11/20/1019
CAL WST 32-002

Subject: Airliner Welded Axle Seats

**Models Affected: 2019 and 2020 model year Western Star 4700,
5700XE, and 4900SB vehicles**

Work Instructions

Fig. 1, Airliner Suspension Rear Rear Drive Axle

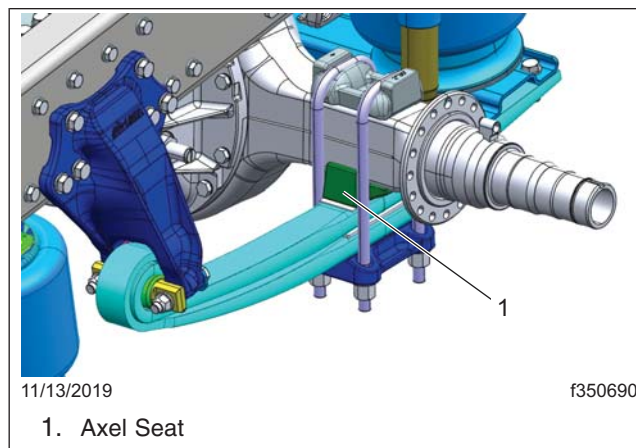
The Airliner rear suspension welded axle seats were installed incorrectly on the rear most drive axle on these vehicles, resulting in an incorrect axle pinion angle.

8. Cut off the existing left-hand and right-hand axle seats.

1. Park the vehicle, shut down the engine, and apply the parking brakes. Chock the steer axle tires and the rear rear drive axle tires.
2. Dump the air from the Airliner rear suspension air springs.
3. Raise the truck and support the back of the frame rails with appropriate support stands. Make sure the tires are still touching the ground.
4. Remove both air springs on the rear rear drive axle. See **Section 32** in the *Western Star Workshop Manual* for instructions.
5. Disconnect the shock absorbers from the leaf springs on the rear rear drive axle.
6. Remove both of the Airliner leaf springs on the rear rear drive axle.
7. Locate the welded axles located on the bottom of the axle housing. See **Fig. 1**.

Fig. 2, Locating the Center of the New Axle Seat

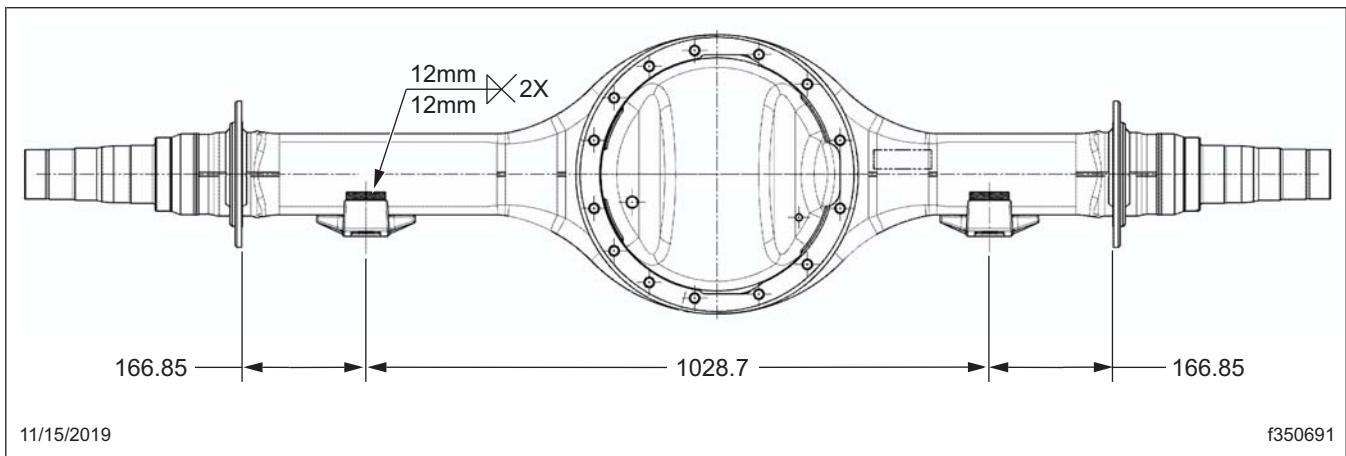
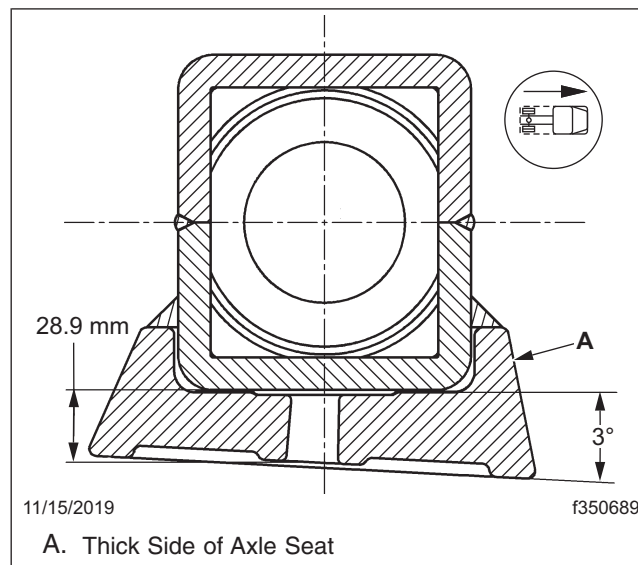
9. Use a disc grinder to grind out the welds and remove the axle seats. Discard the axle seats.
10. Remove any weld residue, ridges, or ripples from the surface of the housing. Do not leave gouges or sharp edges on any surface. All areas must be flat with the housing wall and bracket.
11. Grind off the outer coating on the welding surfaces of the new axle seats.
12. Locate the center of the new axle seat 6.57 inches (166.85 mm) from the inside of the brake flange with the thick side of the axle seat located on the forward side of the axle housing. See [Fig. 2](#) and [Fig. 3](#).

13. Complete the .5 inch (12 mm) weld. See [Fig. 2](#)
14. Install the leaf springs. See **Section 32** in the *Western Star Workshop Manual* for full instructions on installing the leaf springs. Torque the U-bolts as specified in the **Western Star Workshop Manual** in **Subject 32.04.400**.
15. Install the shock absorbers.
